09 February 2026

211541 CAAL

173-179 Walker Street, North Sydney

Proposed Changes to Early Works Stormwater Diversion (SSD-67175465)

FOR APPROVAL

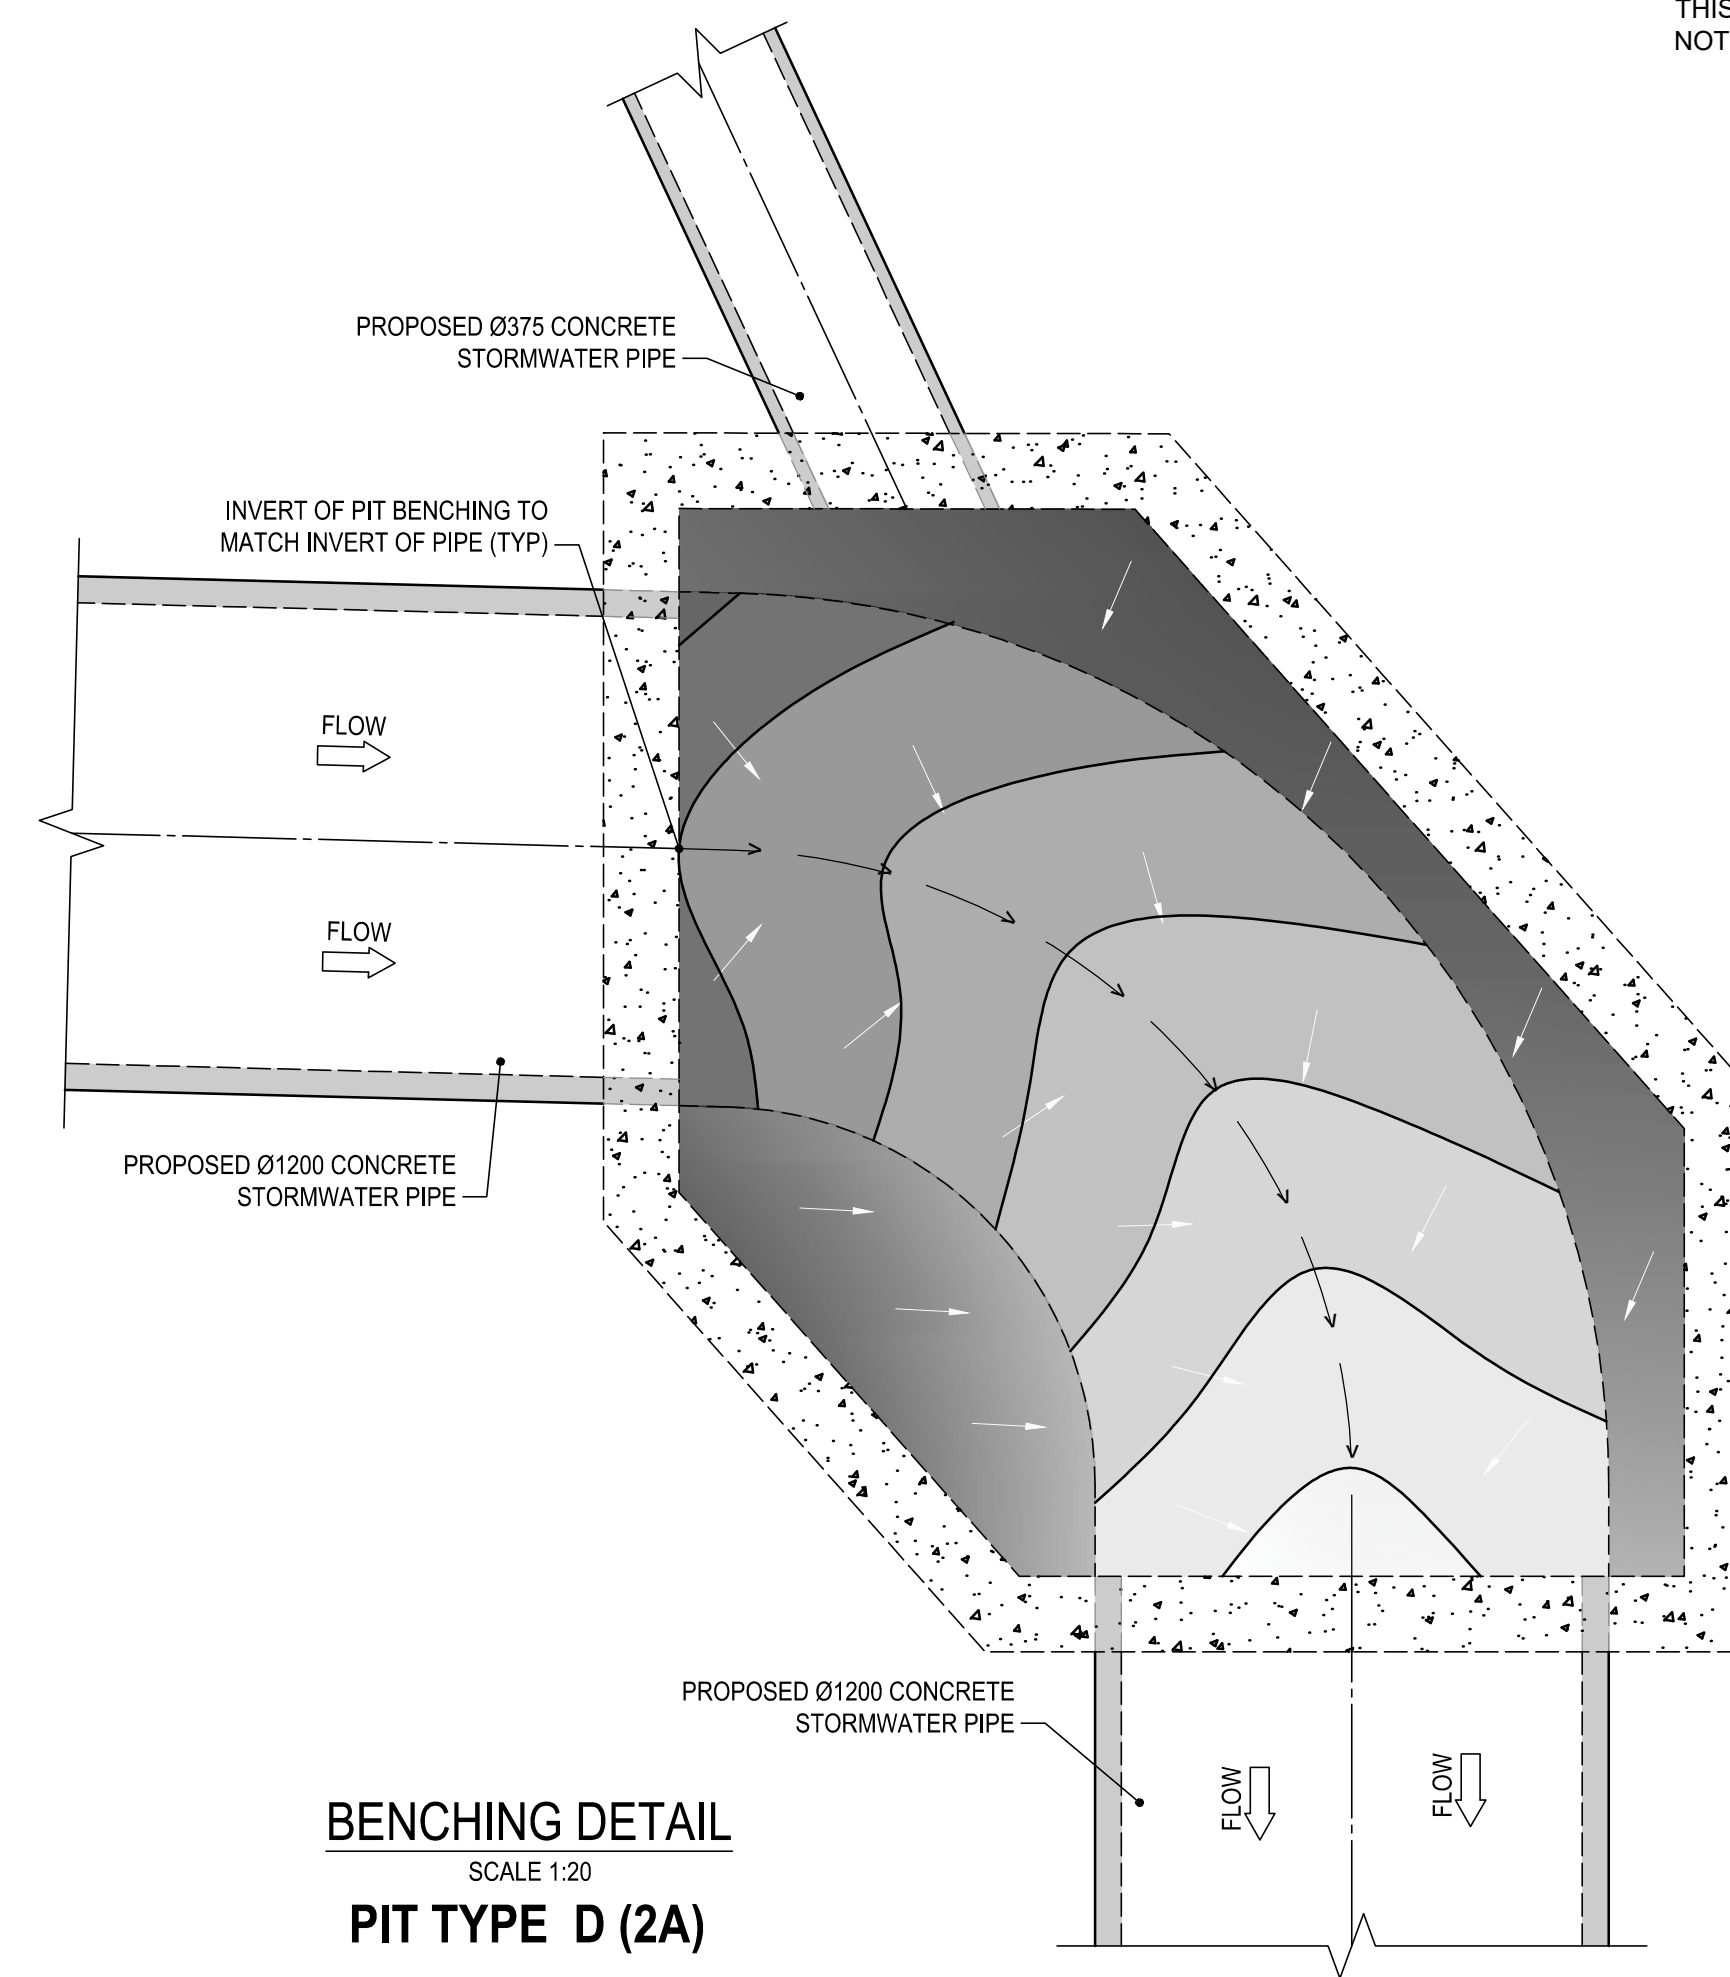
1. Relocation of Proposed 5-Grate/Lintel Pit with Stone Inlet (Pit 7A)

Site investigations have confirmed that the existing 860mm × 1000mm box culvert traverses the site in a perpendicular alignment to the retaining wall, rather than the diagonal alignment shown on the original survey. To reflect the confirmed culvert alignment, reduce on-site construction complexity, and utilise existing pits to achieve a direct connection, it is proposed to relocate Pit 7A directly over the existing box culvert.
